Re. Response to Council further information requests for the Notices of Requirement (EB3C and EB4L Packages)

The Eastern Busway Alliance (EBA) on behalf of Auckland Transport are writing in response to Auckland Council's (the Council) request for further information dated 20th October 2023 for the NoR's for Eastern Busway 3 Commercial (EB3C) and Eastern Busway 4 Link (EB4L).

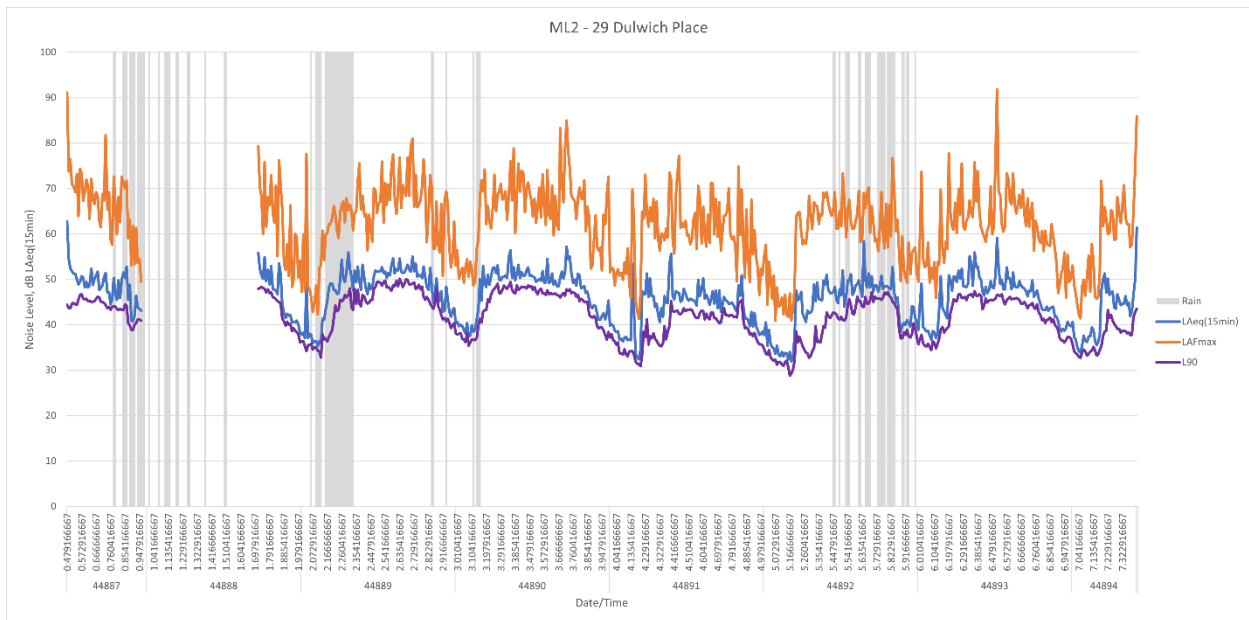
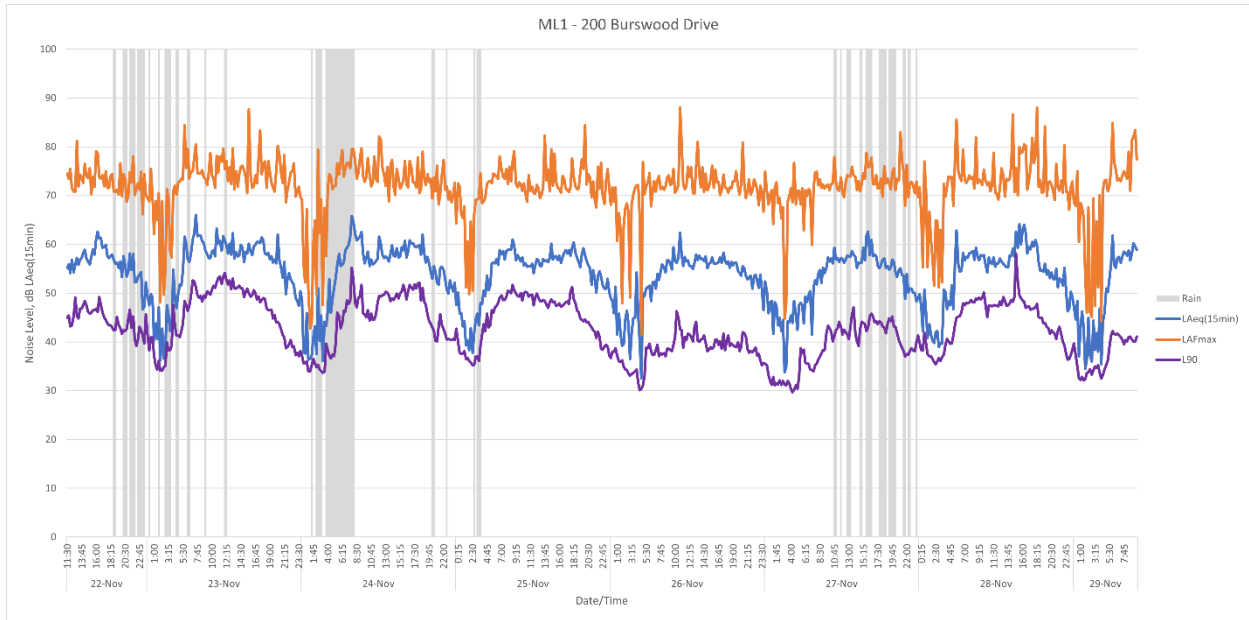
A3 *Please adjust the ambient noise measurements to remove the effects of crickets and cicada noise.*

Cicadas and crickets have not significantly increased the measured noise levels used in the assessment. Observations made during attended measurements confirmed that these are free from the influence of insect noise. Analysis of the unattended logging results at 200 Burswood Drive and 29 Dulwich Place indicate that these are not significantly affected by crickets and cicada noise as removal of the higher 1/3 octave bands results in a change in overall noise level of less than 1 dB.

View Southwest from Heathridge Place

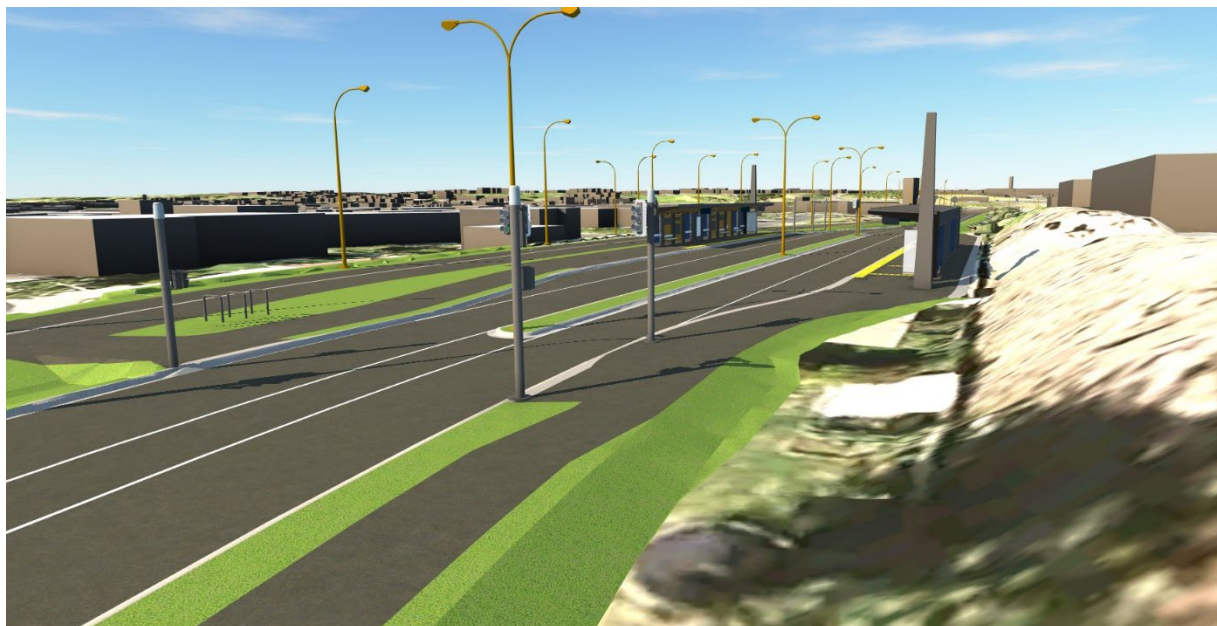
UD3 *Please provide perspective views (inclusive of landscaping and elevations) to understand the visibility of the bus stop platforms from the cul-de-sacs of Dulwich Pl. and Heathridge Pl.*

Please see the figures below which have been extracted from the Developing Design Model. These figures are a work in progress and further images can be provided as the detailed design of the project progresses. These images have been provided to provide an indication of the perspectives requested. It is noted that these images do not include noise walls. An artistic rendition has also been provided to show a representation of what Burswood station will look like.
